- A. 91-13664 Bearing Carrier Tool – 6, 8, 9.9 & 15 HP Models
- B. Commander 2000 Remote Control Warning Horn Buzzing – 3 Cylinder Model 70-75-80-90 and 4 Cylinder Model 100
- C. Modified Propeller for Trouble-Shooting Mag II/XR 4 Models
- D. E.C.U. Test Readings – Mariner/Mercury 220

A. 91-13664 BEARING CARRIER TOOL 6, 8, 9.9 & 15 HP MODELS

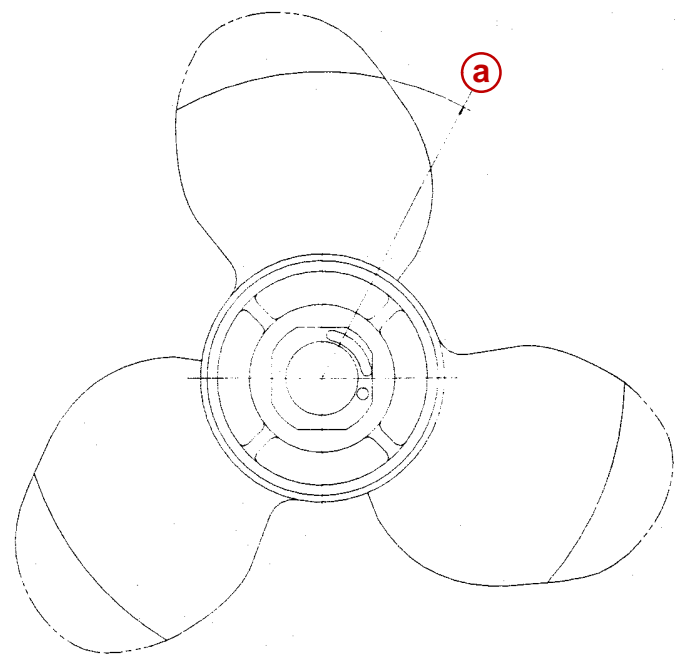
The four (4) slots in the tool must have the widths increased by 1/8" for a total of 7/16". Refer to drawing below.

a - 4 Slots Original Width 5/16" Increase Width to 7/16"
